# Access Compliance Report

## Public Rights-of-Way

| Intersection ID: 28386 | Main Street: MARVIN_RD | Cross Street: SOUTHAMPTON_COMMONS_DR | Location: S            |
| ADA ID: 5B1330BD10C8   | Ramp Type: PerpDiag    | Initial Pass/Fail: Fail              | Overall Compliance: No |

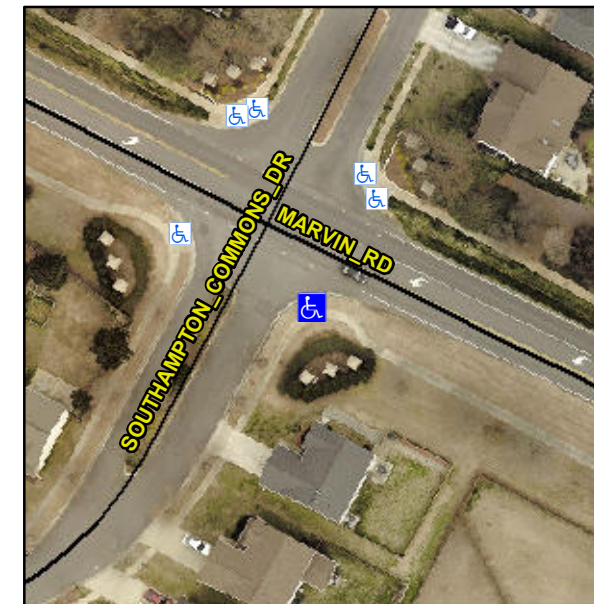
Possible Solutions:

**Remove & Replace Curb Ramp With Two New Directional Ramps or Equivalent.**

PROW/ADA:

**R304.5.1, R304.5.3**

| Compliance | Description           | Data  | Compliance | Description                 | Data  |
|------------|-----------------------|-------|------------|-----------------------------|-------|
| No         | Ramp Width (in)       | 35.0  | No         | Ramp XSlope (%)             | 5.1   |
